Middleton City Council

Findings of Facts, Conclusions of Law & Order

In the Matter of the application of Briggs Miller and Kyle Miller for preliminary plat and waiver with respect to the Heights Landing Subdivision located at 23443 Cemetery Road:

STAFF REVIEW AND REPORT

PRELIMINARY PLAT
 FOR
 HEIGHTS LANDING SUBDIVISION
 A PART OF THE NW 1/4, SECTION 06, T.3N, R.2W, B.M.,
 CITY OF MIDDLETON, CANYON COUNTY, IDAHO
 2024

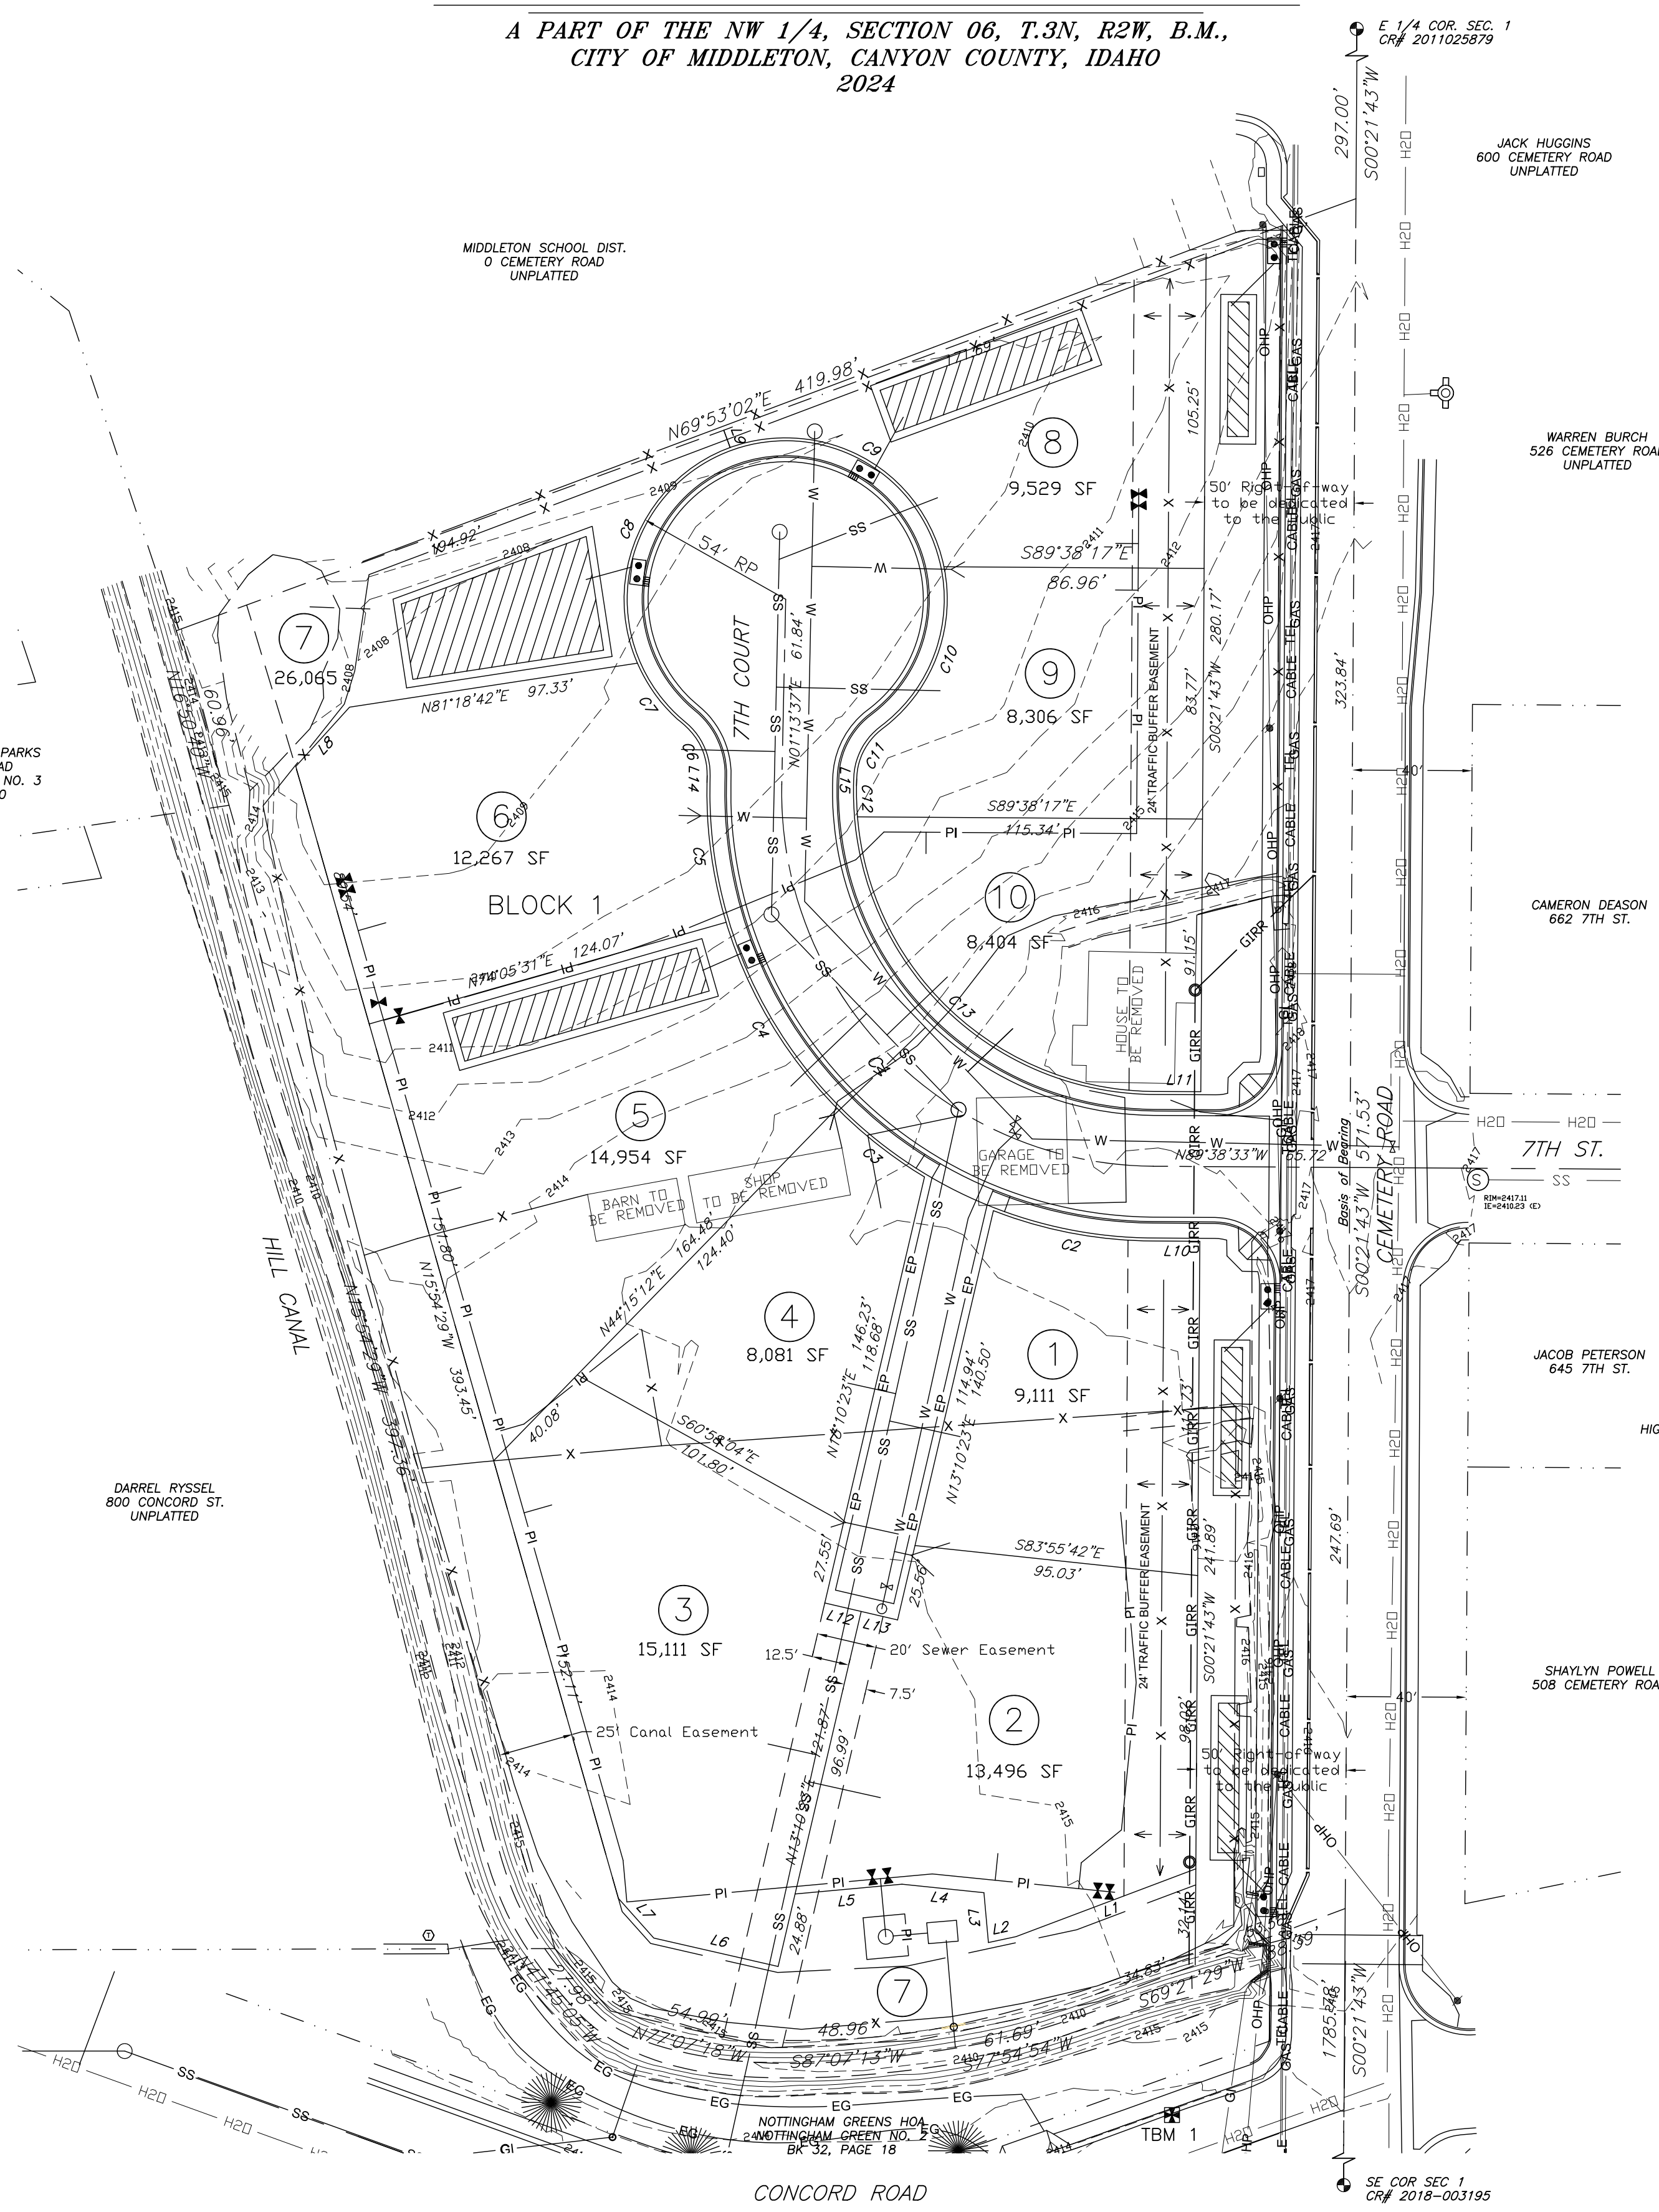
- 1. The width of the local roads are not called out and the typical street section for local roads is missing. (MCC 5-4-4(A)(2)(h))*
- 2. The width and design for Cemetery Road frontage is not shown on the preliminary plat in violation of MCC 5-4-4(A)(2)(h). The Preliminary Plat does not establish nor show the variance request to design Cemetery Road to match the design in front of Heights Elementary to the north and the 7th Day Adventist church parcel to the south (MCC 1-15-2).*

- 3. The location and width of sidewalks are not shown. (MCC 5-4-4(A)(2)(h))*
- 4. The location of canals, drains with direction of flow are not identified on the plat in addition to easements attached to the drains. (MCC 5-4-4(A)(2)(g)) (Applicant failed to provide a Title Report to show existing easements despite repeated requests for the title report).*

- 5. The location of streetlights are not shown as required by MCC 5-4-4(A)(2)(n).*

- 1. Multiple requests to add the following: (1) note prohibiting driveway access off of Cemetery Road, (2) note regarding requirement of extending network fiber to the site, (3) note showing mailbox location, (4) note identifying irrigation district and assessment information (5) note that exterior boundary to be fenced, (6) request to remove note regarding "right to farm", and (7) request to show all easements to be established.*
- 2. All requests for a title report have also been ignored. A title report is necessary for planner and engineer to determine if any easements, covenants or Development Agreements are attached to the land. Currently, planner and engineer are blind in this regard.*

As to the waiver request to construct the street frontage so that it matches the street frontage existing in front of Heights Elementary to the north and the church parcel to the south, Applicant has not submitted a preliminary plat that shows that revised street frontage configuration.

Request the applicant review MCC 5-4-4 and confirm in writing to the City that each item listed has been included on the preliminary plat submittal.

The City will not own and operate a sewer lift station for 12 residential lots. Please review options to gravity sewer the project including tie into the manhole at Garden Street or adding fill to the site.

Show Concord Street on the south boundary. Can the new street be developed off Concord?

A 24ft easement for traffic buffer is required along Cemetery.

Gravity irrigation is required to be relocated out of right of way. Please clearly show gravity irrigation and where it will be relocated.

Stormwater. Plan to manage a 100 year/1 hour storm using retention facilities only. No subsurface. The front half of the lot C value is 0.75, the rights of way/impervious (all) are 0.95. All stormwater management facilities require pretreatment. Stormwater facilities are owned by HOA and the provisions for maintenance laid out in CCRs. Identify lots to be used for stormwater management.

Reduce the plat to one page if possible. Dimension and clearly identify every lot. Do not provide contours after grading the plat. That may be provided as an exhibit if you would like.

Add note regarding easements to be established.

Address irrigation per Idaho Code 31-3805.b. Identify the irrigation district. Show the irrigation system layout and point of diversion/pump station location.

Add note: No direct access to Cemetery.

Add a note regarding fiber.

Add a note exterior boundary is required to be fenced.

Show mail box/USPS location.

Add street name.

Dimension and label lateral.

Add centerline radii and intersection radii.

Before you resubmit, print out of a pdf of the plat and review it on your end against the code and as a team. The plat should be clearly legible with very few drafting problems, conflicting line types, boundary identified and legible, etc.

A 24ft easement for traffic buffer is required along Cemetery. Please add note if a variance is requested.

Gravity irrigation is required to be relocated out of right of way. Please clearly show gravity irrigation and where it will be relocated. The gravity irrigation is not approvable as shown. Irrigation crossings are at 90d.

Stormwater. Plan to manage a 100 year/1 hour storm using retention facilities only. No subsurface. The front half of the lot C value is 0.75, the rights of way/impervious (all) are 0.95. All stormwater management facilities require pretreatment. Stormwater facilities are owned by HOA and the provisions for maintenance laid out in CCRs. Identify lots to be used for stormwater management. Submit stormwater preliminary analysis.

Add note regarding easements to be established. Review City Code and list easements accordingly. What easement is needed for the existing gravity irrigation.

Address irrigation per Idaho Code 31-3805.b. Identify the irrigation district and whether lots are subject to assessment. Show the irrigation system layout and point of diversion/pump station location.

Add note: No direct access to Cemetery.

Add a note regarding fiber.

Add a note exterior boundary is required to be fenced.

Show mail box/USPS location.

Add centerline radii and intersection radii.

Note 11. Delete.

Note 13. Delete.

Add callout to remove/relocated power structures in Cemetery right of way.

Add Middleton Road typical section and local road typical section.

The City cannot create lots that are non-conforming and Lot 14 and the dwelling in place do not meet the requirements of the development code. The structure does not meet setback distance to either street, it fully encroaches into the easement area. It is not clear the new street can be constructed without significant damage to the structure. If structures are to be removed/razed, add a note accordingly. If you wish to leave the structure on Lot 14, City Council will need to grant a variance.

The City will not own and operate a sewer lift station for 12 residential lots. Please review options to gravity sewer the project including tie into the manhole at Garden Street or adding fill to the site. Please add sewer invert information at each manhole so the sewer may be evaluated.

A 24ft easement for traffic buffer is required along Cemetery. Please work with Jennica on a variance if a buffer is not planned to be developed per Code.

Gravity irrigation is required to be relocated out of right of way. Please clearly show gravity irrigation and where it will be relocated.

Stormwater. Plan to manage a 100 year/1 hour storm using retention facilities only. No subsurface. The front half of the lot C value is 0.75, the rights of way/impervious (all) are 0.95. All stormwater management facilities require pretreatment. Stormwater facilities are owned by HOA and the provisions for maintenance laid out in CCRs. Identify lots to be used for stormwater management. Submit stormwater preliminary analysis.

Add note regarding easements to be established. Review City Code and list easements accordingly. What easement is needed for the existing gravity irrigation.

Address irrigation per Idaho Code 31-3805.b. Identify the irrigation district. Show the irrigation system layout and point of diversion/pump station location.

Add note: No direct access to Cemetery.

Add a note regarding fiber.

Add a note exterior boundary is required to be fenced.

Show mail box/USPS location.

Add street name. Street is W 7th Court.

Add centerline radii and intersection radii.

2. MCC 5-4-4 Preliminary Plat – City Code preliminary plat submittal requirements. Please revise plat to specifically note all items outlined: 2(a, b, c, d, e, f, g, h, i, j, k, l, m, o, p, q, r.)

3. Provide a landscape plan.
4. MCC 5-4-4(3d) “Irrigation System: A statement describing the proposed irrigation system, point of delivery, and preliminary layout shall appear on the preliminary plat.”

5. Show and call out all irrigation/ditch easements in development.
6. Add note: Any re-subdivision of this plat shall comply with the applicable regulations in effect at the time of the Re-subdivision.

7. Show right of way and utility easements within right of way. Call out in notes.
8. Roads need to show a turning radius of minimum of 90 ft. Call out in notes.

9. MCC 5-4-10-2: A 24 ft easement/landscape traffic buffer is required along Cemetery.
10. Add note to call out common areas by lot and block and state who owns them.

11. Add note: All lots are residential building lots except lots (insert L/B)
12. Add cluster mailbox(s) in common area(s). Call out in notes.
13. Add note: All streets proposed in this development are public streets and shall be constructed in accordance with City of Middleton standards.

14. Add note explaining how stormwater run-off will be handled.
15. Add note: All existing wells shall be abandoned per IDWR regulations. All septic systems shall be completely removed and the area recompacted per geotechnical report.

16. Add note: Domestic and fire protection water shall be provided by the City of Middleton,
17. Add note: Sanitary Sewer collection shall be provided by the City of Middleton.

18. Address any additional comments from City Engineer, MRFD, CHD4, ITD, Irrigation District.
19. Add note: All building setbacks and dimensional standards shall be in compliance with R-3 zoning at time of building permit issuance.

20. Add note: Fiber optic to be provided to each lot during Joint Trench construction per the City of Middleton Supplement to the ISPWC.
21. Show all public and private easements on preliminary plat.

22. Add note: Lot lines common to street right-of-way contain a 10-foot wide permanent easement for public and private utilities.
23. Add note: All lots are hereby designated as having a permanent easement for public utilities and pedestrian walkway over the five (5) feet adjacent to any interior side lot line, and over the ten (10) feet adjacent to any rear lot line of subdivision boundary.

24. Add note: Sewer and water capacity shall be reserved when City approves construction drawings.

1. Show and call out all irrigation/ditch easements in development. **Cannot decipher**
2. Show right of way and utility easements within right of way. Call out in notes. **Cannot decipher**

3. Roads need to show a turning radius of minimum of 90 ft. Call out in notes. **Cannot decipher**
4. **MCC 5-4-10-2: A 24 ft easement/landscape traffic buffer is required along Cemetery. We need to discuss this and possible waivers.**

5. Add note to call out common areas by lot and block and state who owns them.
6. Add note: All lots are residential building lots except lots (insert L/B)

7. Add cluster mailbox(s) in common area(s). Call out in notes. **It might be a good idea to add a cluster mailbox to lot 11.**
8. Add note: All streets proposed in this development are public streets **except the private drive** and shall be constructed in accordance with City of Middleton standards.

9. Add note: All existing wells shall be abandoned per IDWR regulations. All septic systems shall be completely removed and the area recompacted per geotechnical report.

10. Add note: Domestic and fire protection water shall be provided by the City of Middleton,
11. Add note: Fiber optic to be provided to each lot during Joint Trench construction per the City of Middleton Supplement to the ISPWC.

12. Show all public and private easements on preliminary plat. **Cannot decipher**
13. Add note: Lot Lines common to street right-of-way contain a 10-foot wide permanent easement for public and private utilities.

14. **Change note 15 to read:** All lots are hereby designated as having a permanent easement for public utilities and pedestrian walkway over the five (5) feet adjacent to any interior side lot line, and over the ten (10) feet adjacent to any rear lot line of subdivision boundary.

15. Add note: Sewer and water capacity shall be reserved when City approves construction drawings.
16. **Miller Ave cannot be used as a street name. The main road will be 7th Street Court. Please submit a name for the private drive.**

1. Change the preliminary plat to show that the existing house will be removed as you indicated in our verbal conversations. As shown, it violates the setbacks because it is 0' setback on the side and 0' setback on the front. We cannot create a lot with such setback violations.

2. Add note "All existing homes, shops, garages, and out-buildings will be removed during construction and before the application for final plat."
3. Submit a Title Report for the property and ensure it includes hyperlinks

4. Submit a landscape plan
5. Without a Title Report, which has been requested for two years, we cannot fully determine the extent of the irrigation ditch easements. I suspect they will be significant. I am unable to find them on this preliminary plat. This issue needs to be shown more clearly.

6. Provide proof that you have submitted an application to Drainage Ditch #2. We will not move forward to P&Z without proof of this application being submitted. We will not move forward to City Council without proof that Drainage Ditch #2 approved your preliminary plat.

7. Add note: "Drainage District No. 2 owns two or more easements on the project parcels. Developer must submit an application to DD#2 and DD#2 must approve the proposed preliminary plat prior to submittal of the preliminary plat to City Council."

8. Re-name "7th Court" to "7th Street Court".
9. Show the width of 7th Street Court
10. Add City's local street section as found in the Supplement to ISPWC

11. Our code does not permit private road easements. Please remove 25' private road easement from pplat.
12. Instead, you can use a private lane per Item 4, page 29 of our Supplement to the ISPWC. A private lane cannot under any circumstances access more than 4 home lots. Currently your plat shows that 6 lots will be accessed. Remove 2 home lots or otherwise design the pplat. Also, the private lane cannot be over 150' long without a hammer head for fire truck turn around.

13. Name the private lane "Heights Landing Avenue." Show the dimensional width of the private lane. Reserve this name with Tony Almeida at Canyon County.

14. Assign a lot number to the private lane.
15. Add note: "Lot -?--, Block 1 is a private lane, which is to be encumbered on the final plat with a public access and utility easement. The HOA is responsible for maintaining and repairing the private lane."

16. Add "Block 1" to your pplat so you show proper legal descriptions.
17. Work with Amy Woodruff to add note regarding waiver to the 3 lane urban ROW. It must match closely the ROW design on the school property to the north and the church property directly to the south. Instead of the 8' detached asphalt pavement, it will be 5' wide attached sidewalk, ped ramps and some sort of ditch to handle stormwater. The sidewalks currently showing look wrong. Work with Amy please.

20. Lots 7, 8, & 9 definitely do not show the 75' frontage width required by code. You can measure it at the 25' setback line, but it still does not get to 75' wide.

21. Add the lot frontage dimensions to every lot so it is easy to determine if you have met the code for frontage. The four lots on the private lane must also have 75' wide frontage

22. Call out which lot is a common lot and state its purpose—irrigation? Green space? Buffer??
23. Add note *"No lot shall have direct access to Cemetery Road."*

24. Show perimeter fence on your landscape plan or on the preliminary plat.
25. Show location of mailbox clusters. End of cul de sac would probably be a good location.

26. Work out sewer easements that transect the common lot, irrigation easement, and lot owned by neighboring HOA. That looks like it needs some work.
27. Add note: *"Sewer and water capacity is subject to a will-serve analysis, and City will not reserve sewer and water capacity any earlier than Construction Drawing approval."*

28. Add note: *"All existing wells shall be abandoned per IDWR regulations and all septic systems shall be completely removed and the area recompacted per geotechnical report."*

29. Change note 7 regarding setbacks as follows: *"Building setbacks and dimensional standards for this subdivision shall be in compliance with Middleton codes and standards at the time of building permit issuance."*

30. Remove note 8. It makes no sense and has no context.
31. Remove Note 11 for right to farm. That does not apply within city limits.
32. Add note: *"All lots have a permanent easement for public/private utilities, drainage and pedestrian walkways over the 10 feet adjacent to any public right of way. The easement shall not preclude the construction of hard surface driveways and walkways to the lot."*

33. Add note: *"Unless otherwise shown and dimensioned, all lots shall have a permanent easement for public/private utilities, drainage and irrigation over the 5 feet adjacent to any interior lot line and over 10 feet adjacent to any rear lot line or subdivision boundary."*

34. Add note: *"The homeowners' association (HOA) owns and manages the common areas, which include stormwater facilities. A plan for operation, maintenance and repair of stormwater facilities (O&M Plan) has been prepared and shall be recorded with the CC&Rs for the subdivision. The HOA shall use the O&M Plan to maintain, operate and repair the stormwater facilities."*

35. Add a note describing the proposed irrigation system and point of delivery
36. Add note: *"fiber optic to be provided to each lot during joint trench construction per City Supplement to ISPMC"*

37. Show location of any water wells and septic systems on the property.

1. Developer must revise the preliminary plat to remove stormdrain retention ponds from all private home lots and place them in common lots to be owned by the HOA.

2. City water, fire flow and sanitary sewer to be extended to the site.
3. The name of the subdivision road shall be “7th Street Court”.
4. All existing wells and septic systems to be abandoned pursuant to DEQ regulations and standards prior to construction of the subdivision.

5. The existing home and all outbuildings to be demolished and removed from the site prior to construction of the subdivision.
6. Applicant/Developer to comply with all Engineering Conditions of approval attached hereto as Exhibit “D” and comply with all past Engineering comments for the preliminary plat in addition to future Engineering comments pertaining to the construction drawing application and final plat application.

7. Applicant/Developer to comply with all Planner comments for the preliminary plat, Construction Drawing and final plat.
8. All comments of the relevant irrigation district, fire department and City Public Works Department are to be completed and approved.

9. The Cemetery Road frontage adjacent to the project must be constructed so that it matches the Cemetery Road frontage adjacent to Heights Elementary to the north and the church parcel to the south.

10. Developer shall create a plan for operation, maintenance and repair of stormwater facilities (O&M Plan) contained on the project site. The O&M Plan shall be recorded with the CC&Rs. Developer and/or HOA must maintain and operate the subdivision stormwater facilities in compliance with the O&M Plan.
